Summary of Items Discussed in 3/2022 APSEC Discussion Forum on 13 May 2022

SCENARIO 1 (ACOUSTIC FIN \leq 500MM)

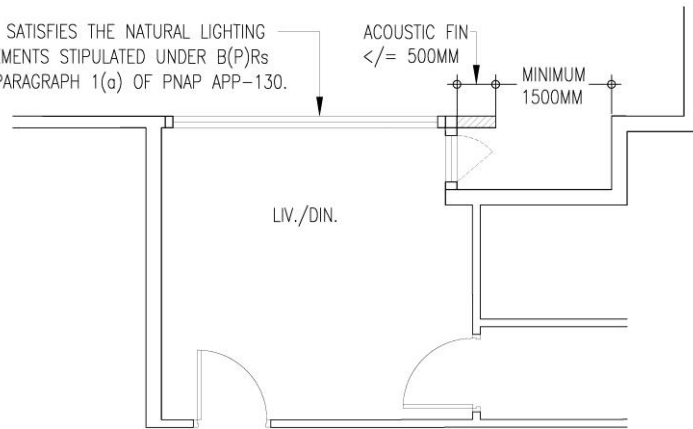
| 5. | <p><u>Natural Ventilation under Performance-based Approach (PNAP APP-130)</u></p> <p>For situation where there is a vertical acoustic fin alongside the external wall for protecting the primary opening from external noise source (such as</p> | <p>BD advised that subject to the requirements stipulated in paragraph 4.1 of Appendix A to PNAP APP-130, Scenario 1 was acceptable.</p> |

traffic noise), we would like BD to confirm that the following 2 scenarios are acceptable to BD:

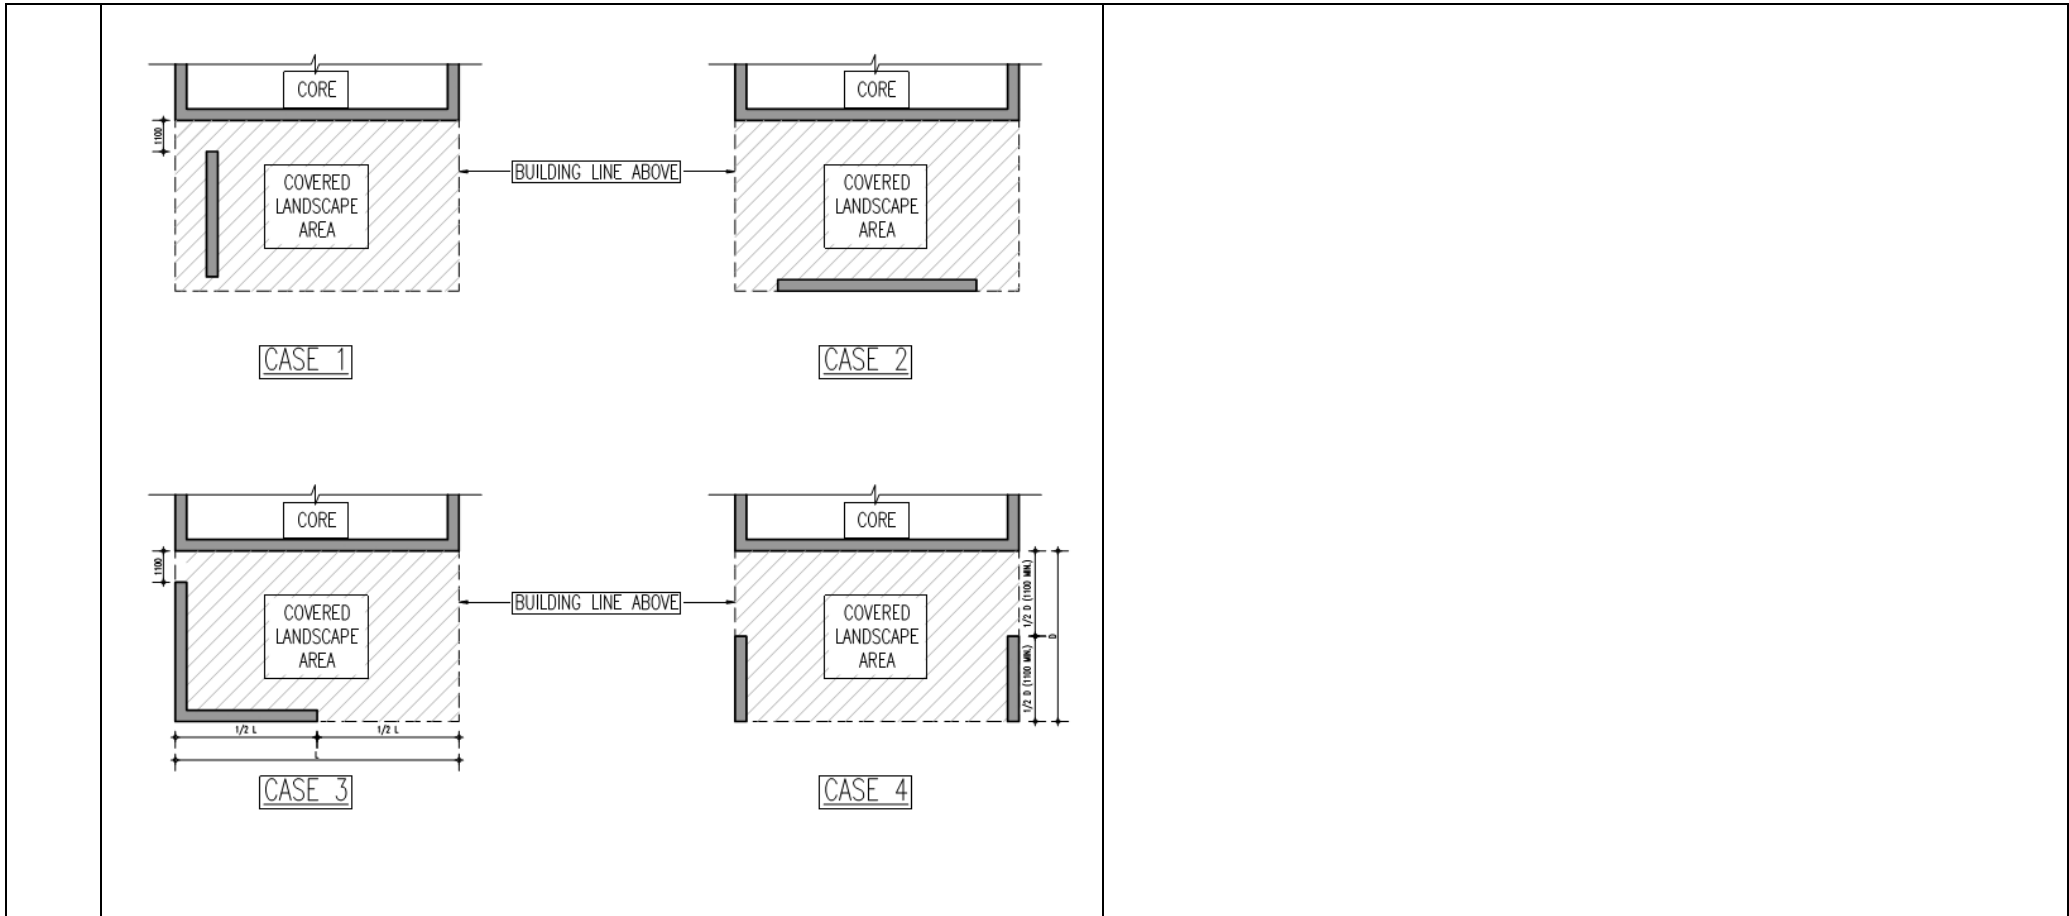
| <p>11.</p> | <p><u>Covered Landscaped Area</u></p> <p>(i) Paragraph 7 of PNAP APP-104 states that open-sided covered landscaped areas/children play areas provided under the footprint of the domestic tower would not be subject to the limitation in Table 1 (i.e. sliding scale of GFA concession for recreational facilities), but should</p> | <p>(i) BD confirmed that AAP’s understanding was correct.</p> <p>(ii) BD advised that according to paragraph 26 of PNAP APP-42, covered landscaped areas/children play areas should be open in</p> |

| <p>be within 5% of the total domestic GFA, details as stated under PNAP APP-42 and subject to compliance with the pre-requisites stipulated in PNAP APP-151 on Building Design to Foster a Quality and Sustainable Built Environment.</p> <p>To our understanding, the above GFA concessions for open-sided covered landscaped area can be applied for:-</p> <p><u>Scenario 1</u> – covered landscaped area only accessible from recreational facilities (with GFA concession under PNAP APP-104);</p> <p><u>Scenario 2</u> – covered landscaped area accessible from both recreational facilities (with GFA concession under PNAP APP-104) and other common area of the building.</p> <p>Please advise if our understanding is correct.</p> <p>(ii) To our understanding, the following scenarios are eligible for GFA concessions for open-sided covered landscaped area. Please advise if our understanding is correct:-</p> | <p>design and not encumbered with structural elements. Therefore, covered landscaped area would be acceptable if it was open-sided and abuse was unlikely. Cases 1 to 4 were generally acceptable.</p> |

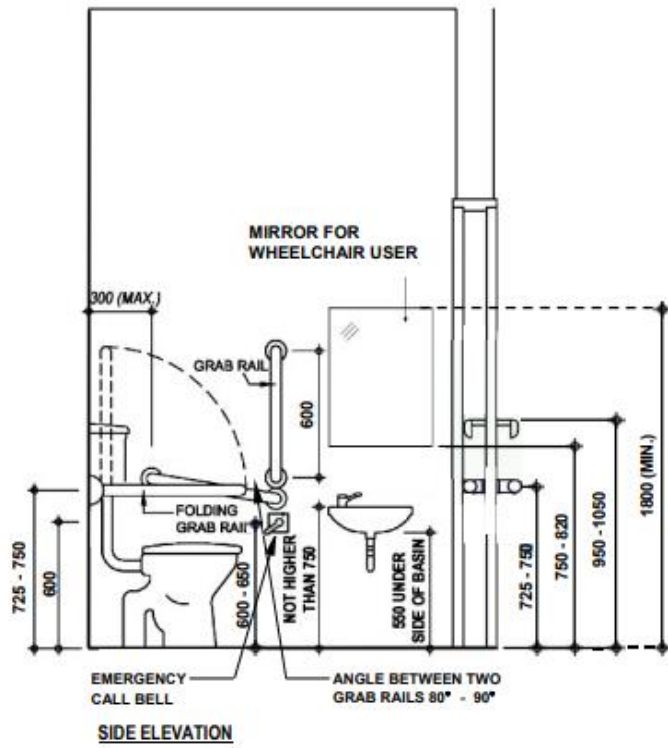
| <p>13.</p> | <p><u>Folding Grab Rail in Accessible Lavatories</u></p> <p>As required in paragraph 53 of the Design Manual: Barrier Free Access 2008 (2021 Edition) (DM:BFA), a folding grab rail has to be installed on the wide side of the cubicle adjacent to the water closet at a height between 725 mm and 750 mm above the finished floor level, when lowered from the wall. Our understanding is that the height shall be measured from the finished floor level to the centre of the grab rail, as shown in the below diagram extracted from Figure 24 of the DM:BFA.</p> <p>However, we have encountered some cases that the said measurement shall be taken from the finished floor level to the top of the grab rail. Would BD please clarify the principle of measurement?</p> <p>Also, the model of folding grab bar commonly available on the market is in U-shape, with two grab rails as shown in the picture below. We would like to know if the measurement shall be taken from the top or bottom rail.</p> | <p>BD advised that the height should be measured from the finished floor level to the centre of the folding grab rail when lowered from the wall, as shown on Figure 24 of the DM:BFA.</p> <p>If U-shaped folding grab bar was adopted, the measurement should be taken to the centre of the top rail.</p> |

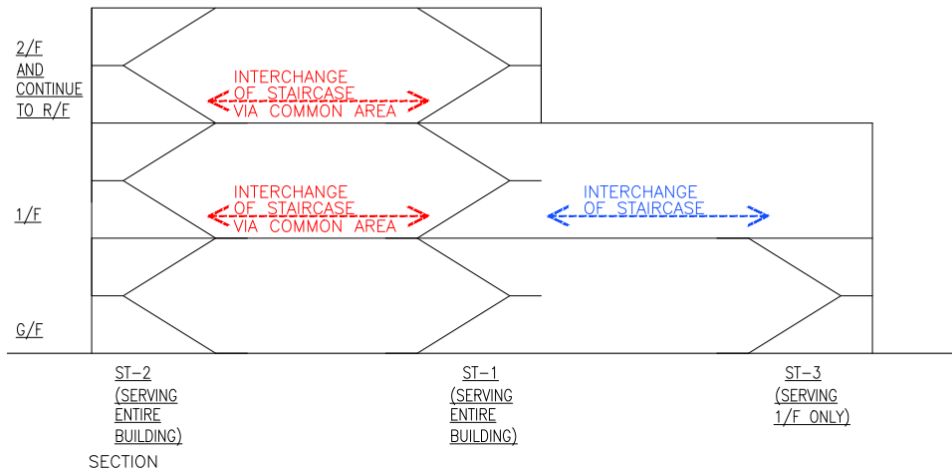
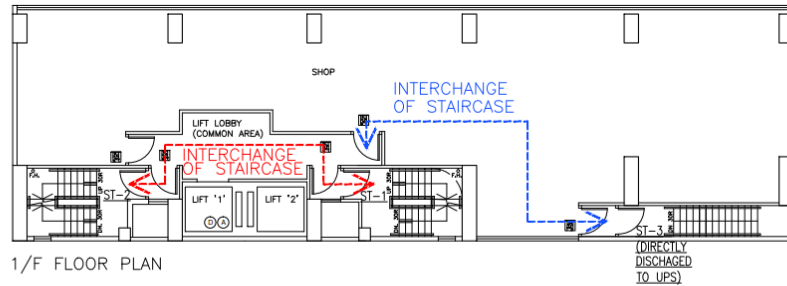
| <p>14.</p> | <p><u>Staircase Interchange</u></p> <p>With reference to Clause B8.2 of the Code of Practice for Fire Safety in Buildings 2011 (FS Code), “<i>Where two or more required staircases are needed, people using one required staircase should be able to gain access to at least one other required staircase at any time, without having to pass through other person’s private premises.</i>” To our understanding, if such staircase (ST-3 in the diagrammatic floor plan below) solely serves the entire occupancy of that floor, for example at 1/F, there is no need to designate a common area, at that floor, for interchange of the subject staircase to any other staircases, as indicated in blue dotted line below.</p> | <p>BD advised that the requirement under Clause B8.2 of the FS Code on access between required staircases would be applicable to all types of buildings and except for shopping arcade situations, passages physically separated from the remainder of the building should be provided as access between the required staircases, and whether fire resisting rating being required for such separations would be governed by Subsection C7 of the FS Code. Such internal common corridor or passage for interchange between required staircases should be shown on the respective floor plans as “common part”.</p> <p>Noting that the staircase ST-3 solely served the single occupancy of the first floor, BD advised that it would favourably consider to accept that no designated common route for interchange of ST-3 need be provided on the condition that the occupants on 1/F can gain access to another required staircase from ST-3 without passing through other person’s private premises.</p> |

Please clarify if our understanding is correct.

CANOPY PROJECTION
PARTLY WITHIN SITE
AND PARTLY OVER STREET

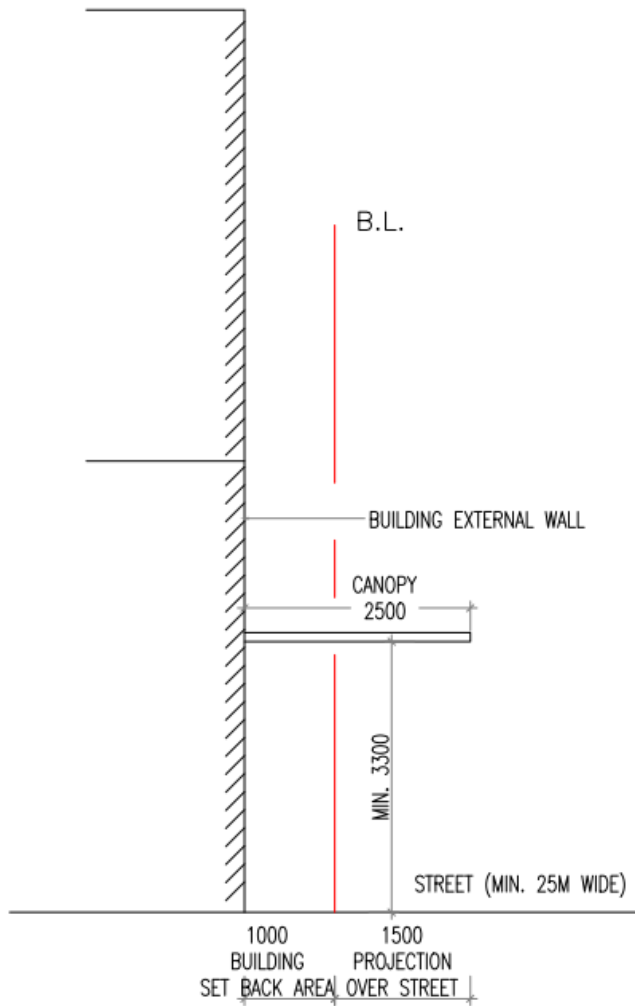
| <p>To our understanding, the condition stipulated in PNAP APP-19 shall only apply to the scenario where the canopy projection is within the site. In case the entrance canopy projection is partly inside the site and partly projecting over the street, and the requirement under regulation 10 of the B(P)R has also been complied with, the covered area of the said canopy within site boundary can also enjoy GFA exemption as per PNAP APP-19. Please confirm if our understanding is correct.</p> | <p>the covered area to a maximum width of 2 m within the site might also be exempted from GFA calculation.</p> |

BD advised that the area covered by a canopy projecting not more than 2 m within the site boundary, over the entrance of a building, might be favourably considered for exemption from GFA calculation as per PNAP APP-19. For an entrance canopy complying with regulation 10 of the B(P)R, which projected partly within the site and partly over the street,

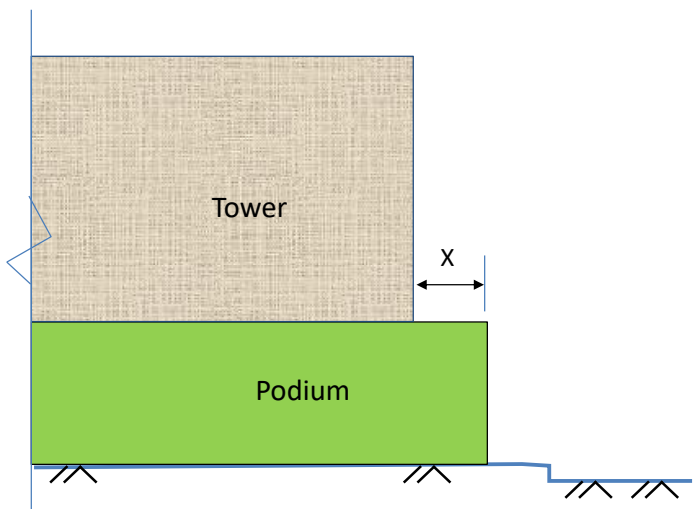
| Items raised by ACEHK | |
|------------------------------|---|
| <p>17.</p> | <p><u>Reinforced Concrete (RC) Beam-Composite Column Joint</u></p> <p>Referring to the above item, the presence of stanchion will also inevitably block the conventional RC beam rebars arrangement and those blocked rebars are probably connected onto the steel stanchion by couplers. The steel section inside the permanent column is thus very strong and able to resist all the unbalanced shear force.</p> <p>In the Code of Practice for the Structural Use of Steel 2011 (2021 Edition) (Steel Code), it is allowed to use the encased steel for column shear force design, and we opine that it should be acceptable to extend the same</p> |
| | <p>principle for RC beam-composite column joint. Can we apply clause 10.5.3.5 (4) of the Steel Code and assume the transverse shear to act on the steel section alone, instead of referring to the Concrete Code?</p> | |
